PUBLIC WORKS DEPARTMENT

Modification of or Addition to Improvement Standards and Details

Modification Number: 082506-1

Modify the standard Roadway and Trench Backfill Standard.

DATE: 06/28/2006		NOT TO SCALE		CITY OF ELK GROVE - DEPARTMENT OF PUBLIC WORKS		APPROVED BY:	
REVISION	BY	APPROVED	DATE	TYPICAL TRENCH COMPACTION DETAIL		CITY ENGINEER	
						DRAWING NUMBER	
						ST - 8

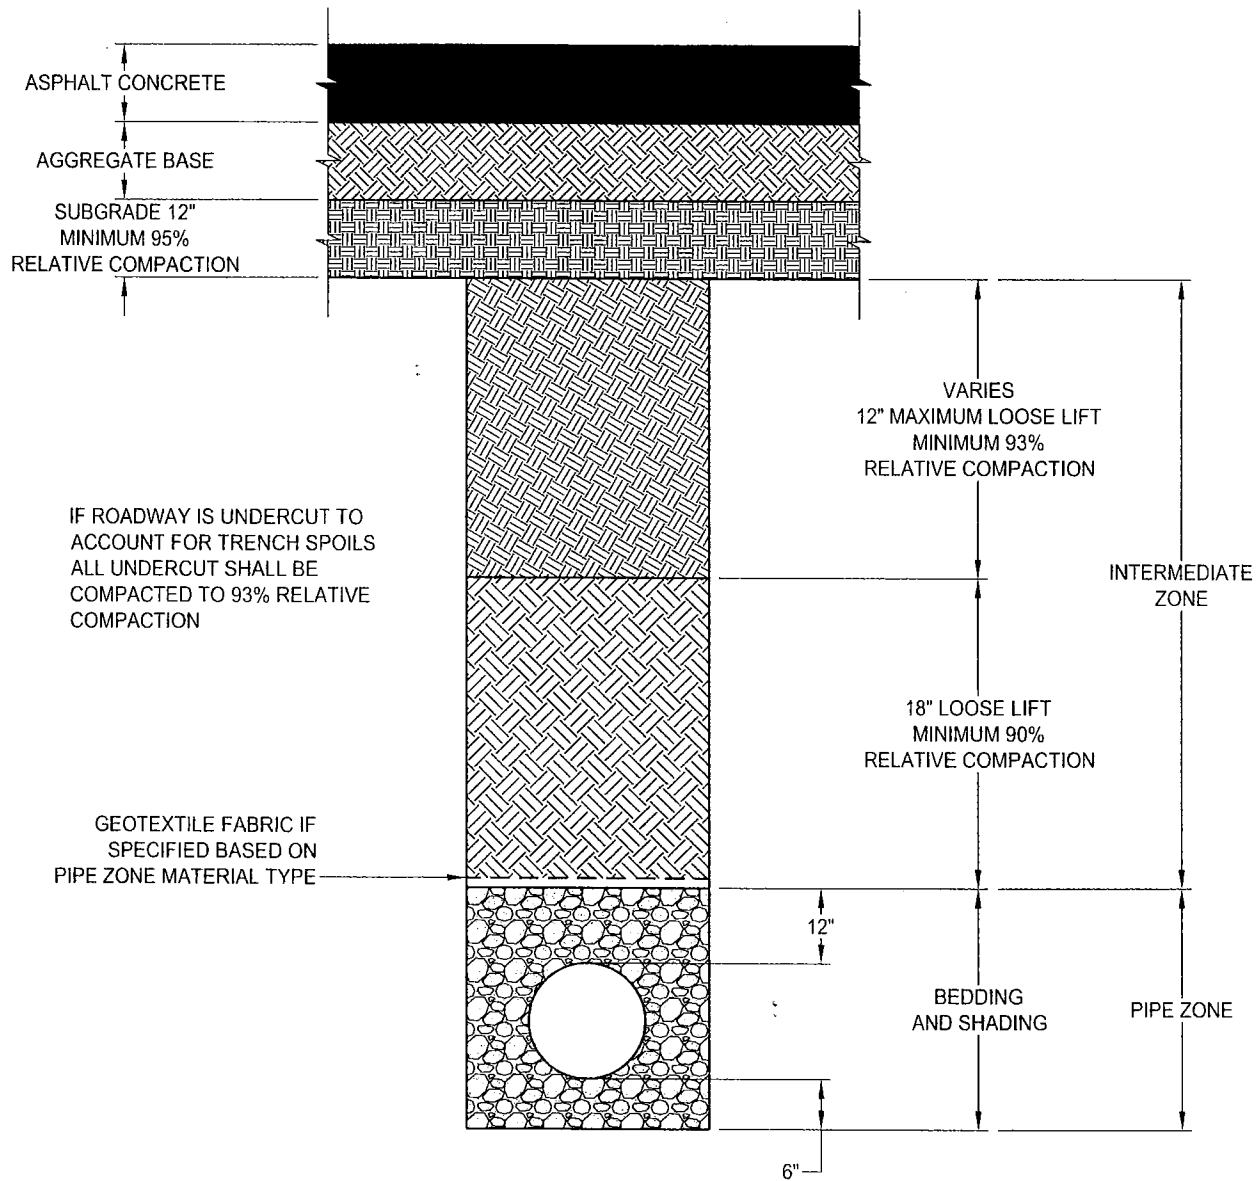
- Replace the typical trench detail with the attached backfill standard drawing labeled ST-8.
- Under the section titled, "Intermediate Zone Backfill", subsection 1. Compaction, paragraph 1, revise the sentence, "All subsequent backfill..." to read, "...achieve a minimum of 93% of the ASTM D1557 maximum dry density."
- Under the section titled, "Subgrade Soils – Roadway, Curb and Gutter, and Sidewalks, subsection 1. Subgrade Preparation, revise the sentence, "However, all material placed...", to read, "...the undercut shall be compacted to at least 93 percent of the ASTM D1557 maximum dry density..."

Modification lowers the compaction requirement for the intermediate zone and trench undercut in roadways from 95% to 93%.
